Technical Parts Gram #63: Oil Pump M-5532492 for ISX Applications

IMCB Style - Pinned Plug

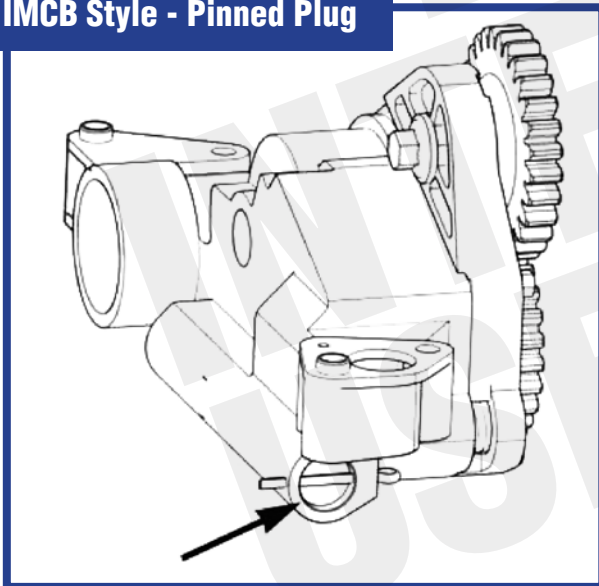
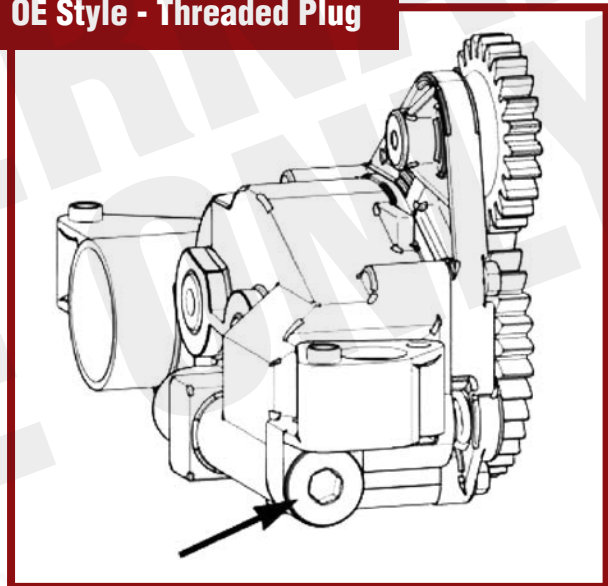
- **Pinned Regulator Plug:** Our current pump includes a pinned regulator plug. (See Comparison Below)
- **OE-Style Comparison:** The original equipment (OE) version features a threaded regulator plug. This is a key difference to be aware of when comparing products. (See Comparison Below)
- **Each pump includes shims:** It is the responsibility of the installing technician to determine whether shims are required to achieve correct gear backlash. For proper installation, always refer to the most recent OEM service manual specific to your engine's configuration.
